**RE: PERMIT APPLICATION TO WIDEN PORTIONS OF FREEPORT  
HARBOR JETTY AND ENTRANCE CHANNEL USING NON-FEDERAL  
FUNDS**

**RE: PERMIT APPLICATION NO. 23752 (FREEPORT HARBOR CHANNEL  
WIDENING)**

We have reviewed your letter dated May 6, 2005 concerning additional information on the above permit application and the discussion with you and others on the USACE staff at the May 24 meeting; and have prepared this response.

SHEET 3 of 8

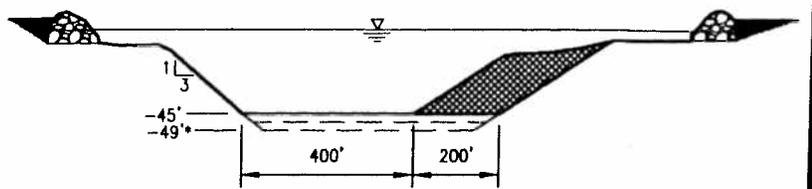
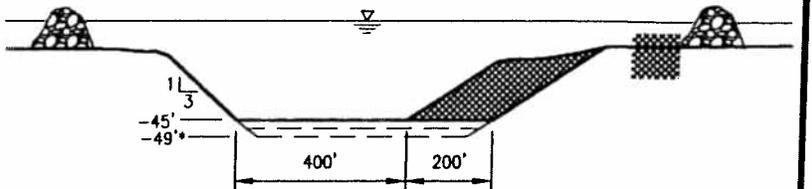
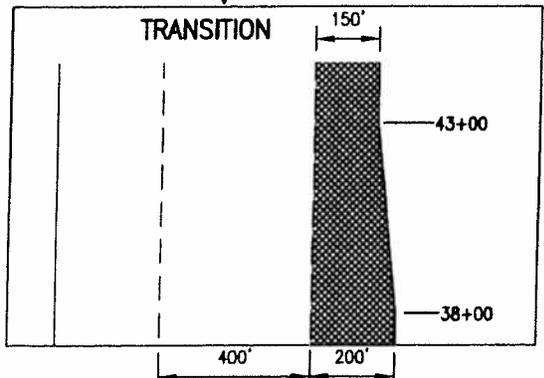
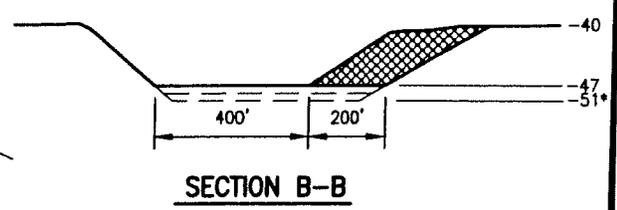
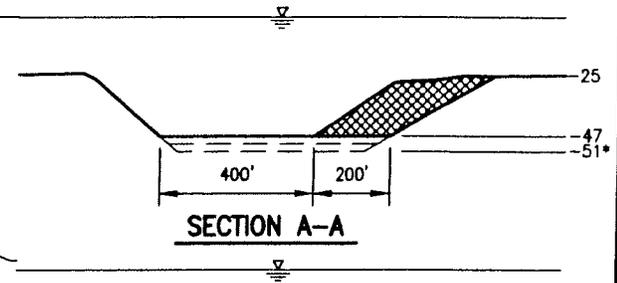
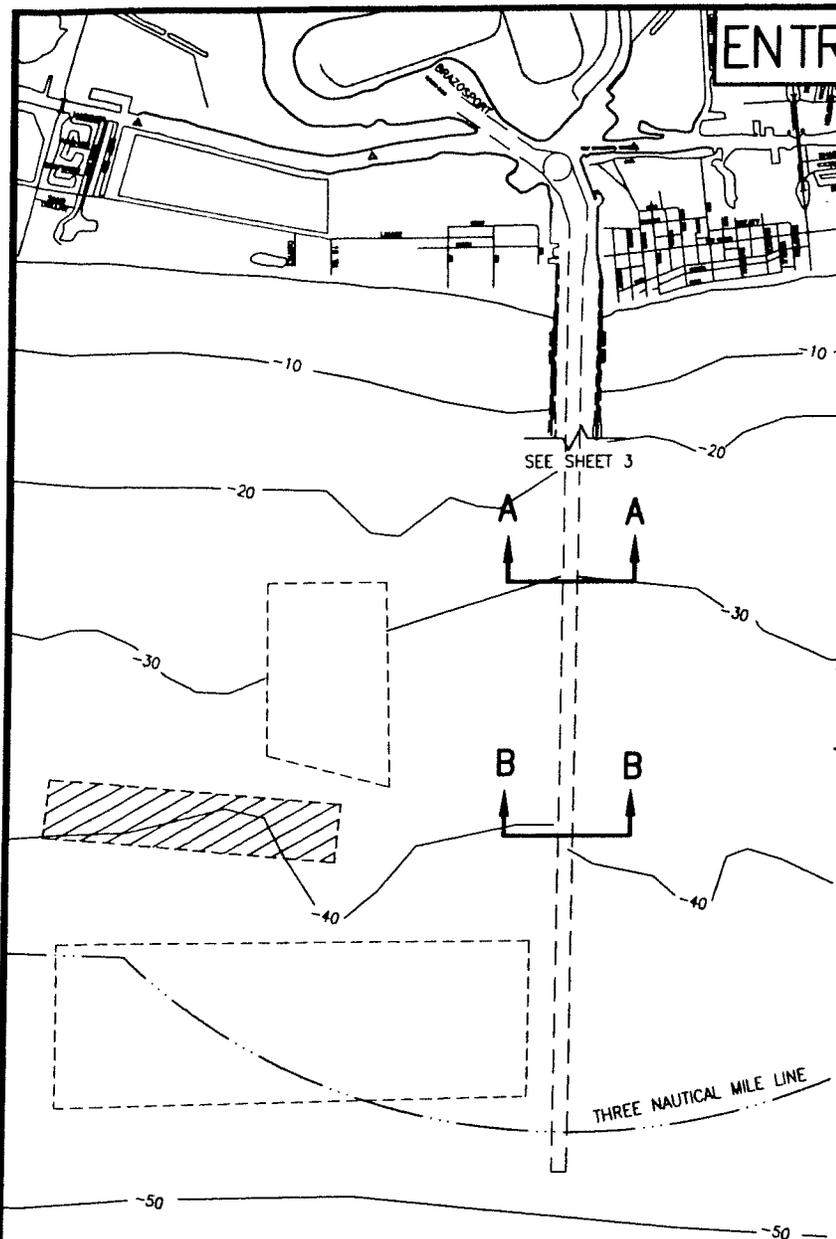
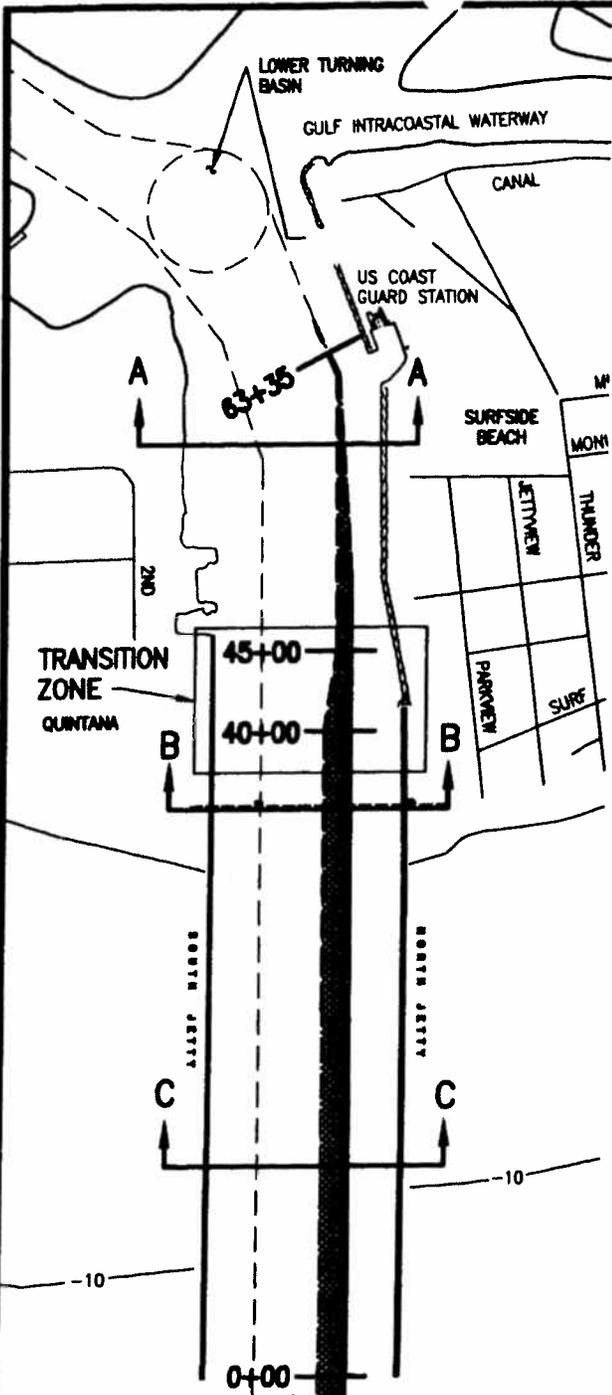
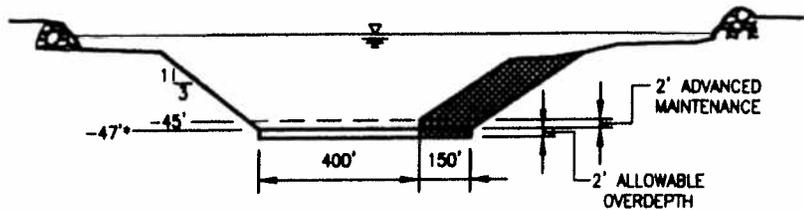
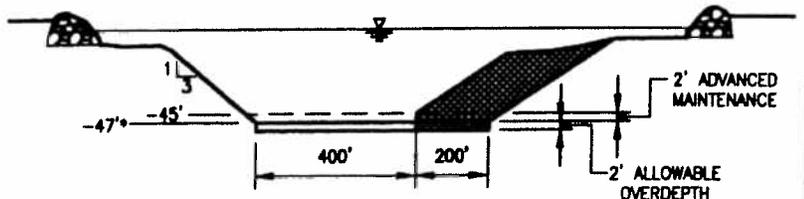
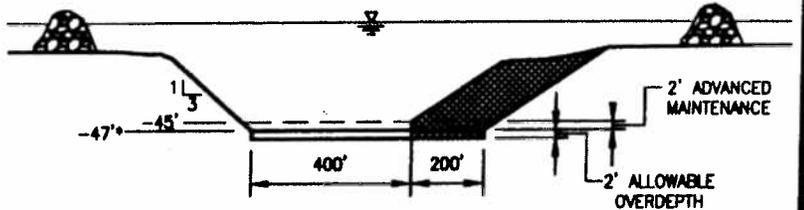
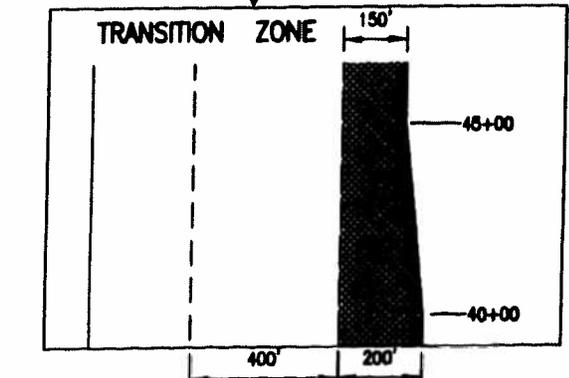
- d. Revise drawings on Sheet 3 of 8 as needed. The transition view shown does not match the plan view above. It also does not match the narrative found in section IV.1 Jetty Stability (page 6) of the project summary. The cross hatching on the upper slopes in the cut sections is not defined.

- e. Sheet 3 of 8, Section C-C shows a dredging area next to the jetty. Please explain.

- f. Sheet 3 of 8, match line should refer to sheet 4 not sheet 6.

- i. Provide the correct channel stations in both the project summary and plans including transition area, cross-sections and work limits. The description of the changes in channel dimensions found in section IV.1 Jetty Stability (first paragraph on page 6 of project summary) is unclear. Station 51+84 is identified as being at the Lower Turning Basin. This station is over 1000 feet seaward of the Coast Guard Station, not at the turning basin.

*Sheet 3 modified to reflect the appropriate stations.*

*Sheet 3 modified to delete.*

*Sheet 3 modified to renumber the match line.*

- *The proposed widening in the Jetty Channel is as follows:*

STATION	WIDEN TO
0+00 to 40+00	600 ft
40+00 to 45+00	Transition from 600 ft to 550 ft
45+00 to 63.35 (outer limits of turning basin)	550 ft

- *Sheet 3 has been modified to properly reflect the above.*
- *The Entrance Channel will be widened from 0+00 to -220+00*

SHEET 4 of 8

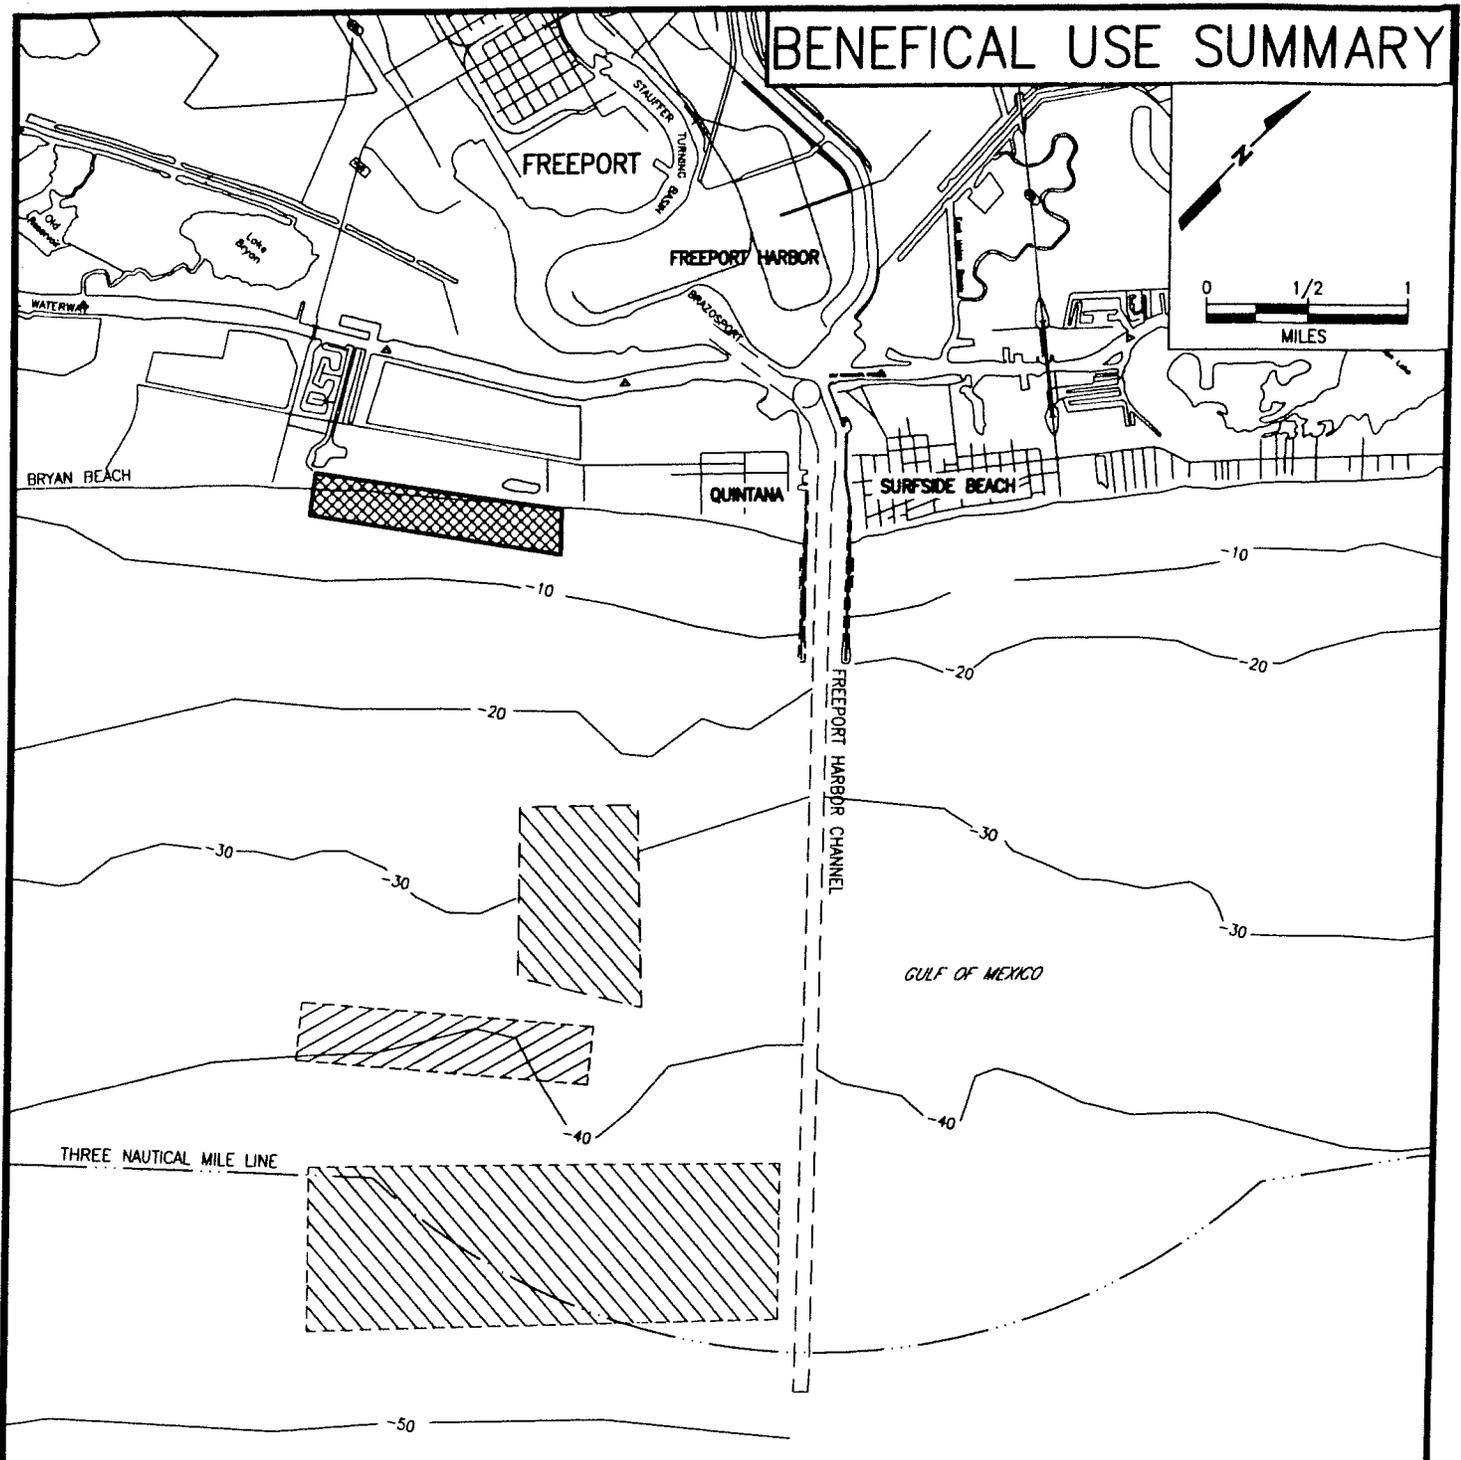
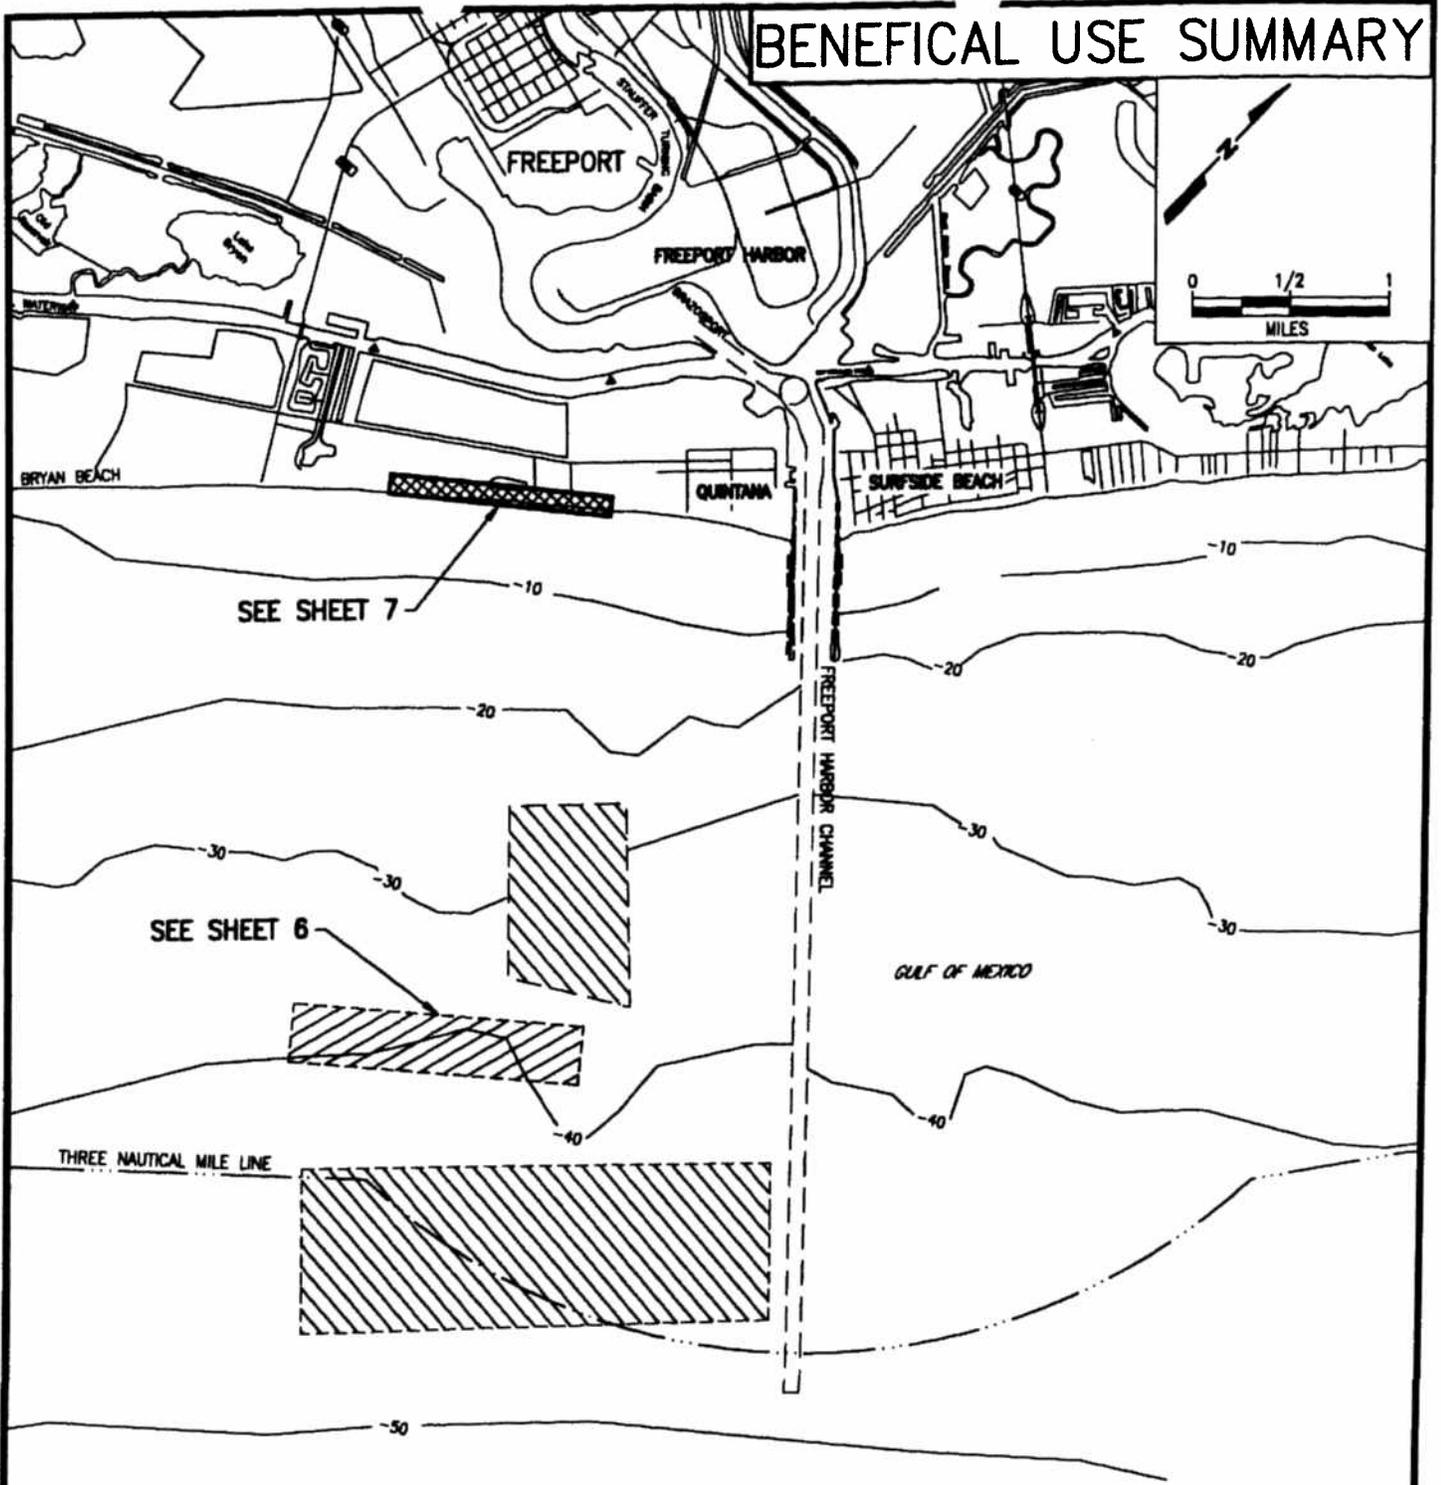
- g. Sheet 4 of 8, legend shows proposed beach nourishment symbol but location of beach nourishment site is not identified on the plans.

*Sheet 4 modified to show beach nourishment location.*

PROJECT No: 200.40142.00 SHEET 6 of 8

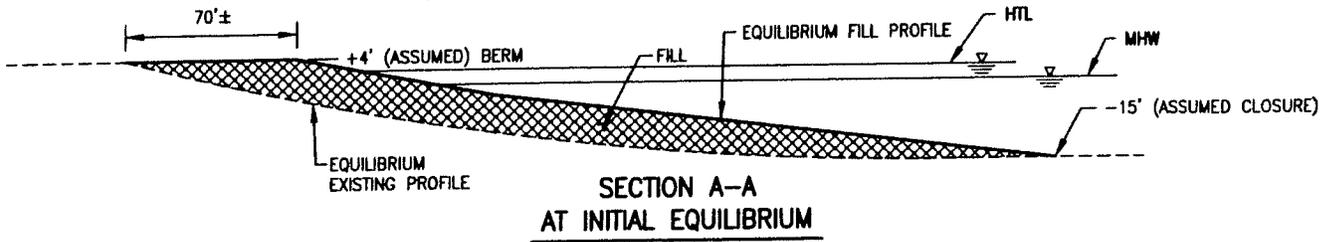
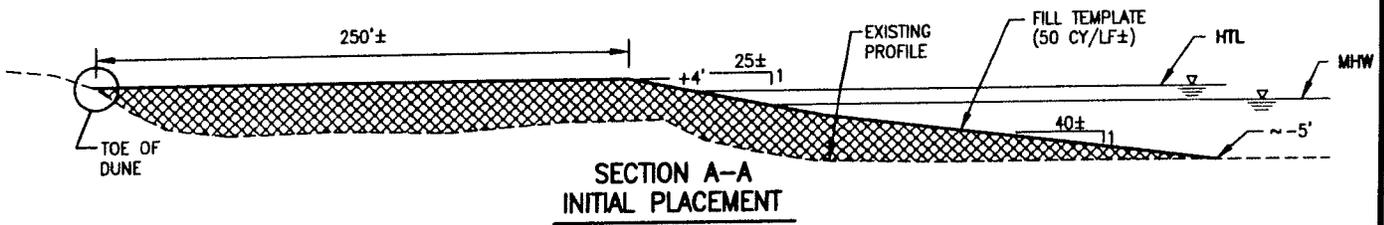
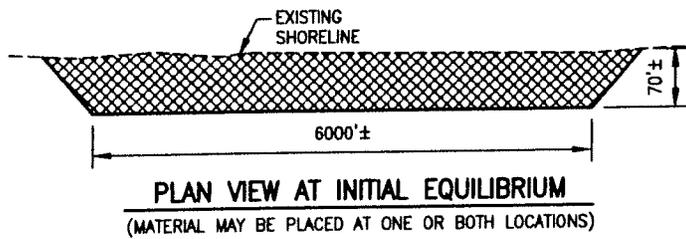
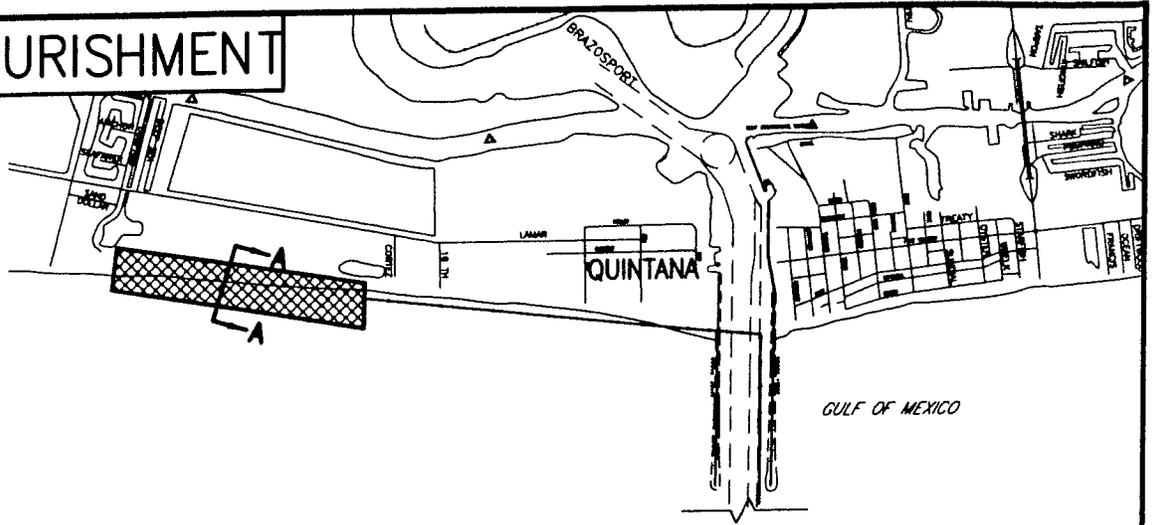
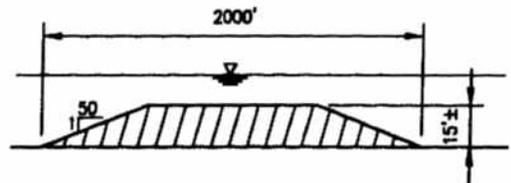
- c. Submit correct coordinates for the BU site. The coordinates of the proposed offshore BU site do not match the coordinates identified in the Scope of Work for the remote sensing survey for historic properties investigations.

- h. Sheet 6 of 8 of project plans, the use of pipelines for dredged material disposal 2 to 3 miles offshore is questioned.

*Sheet 6 modified to show proper coordinates.*

*Although not common in the Galveston District, large pipeline dredges can effectively operate in the Gulf. For example, in Florida, pipeline dredges are frequently used up to 5 miles offshore for beach nourishment. In our discussions with dredging contractors concerning this project, the contractors raised the possibility of using pipeline dredges. In order to get the best price, we would like to maintain the flexibility of using either technology.*

SHEET 7

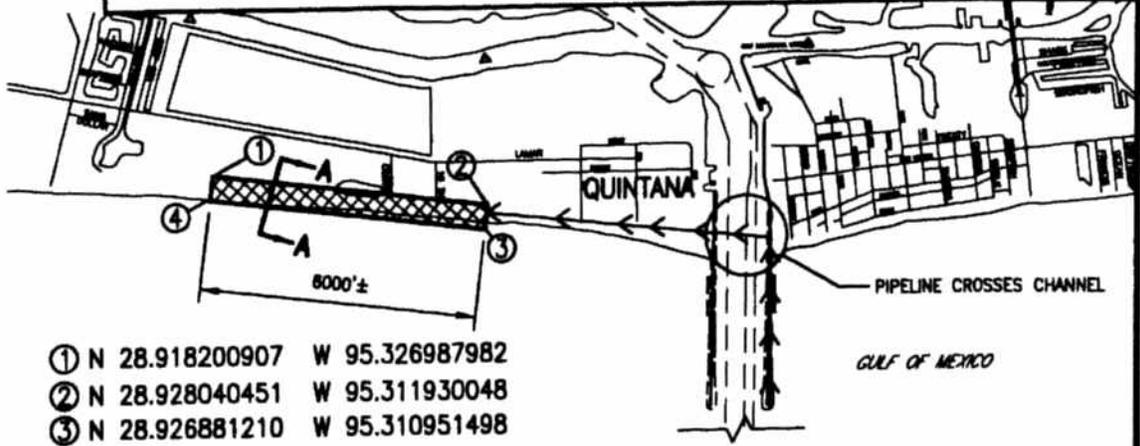
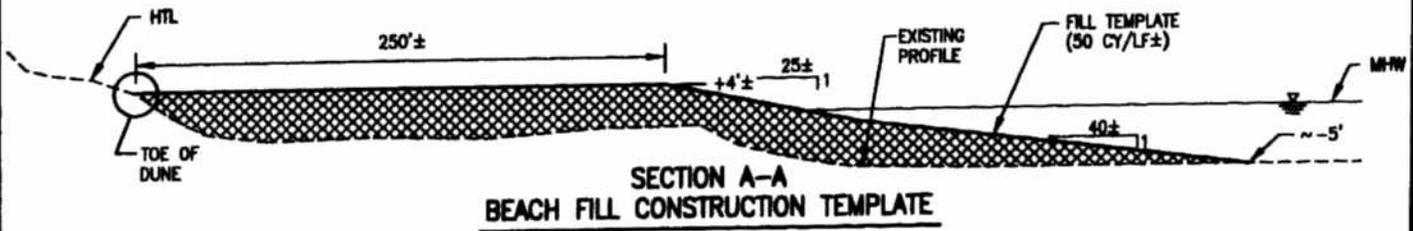
- b. Submit coordinates for each corner of the beach nourishment site for historic property review.

*Sheet 7 modified to show coordinates.*
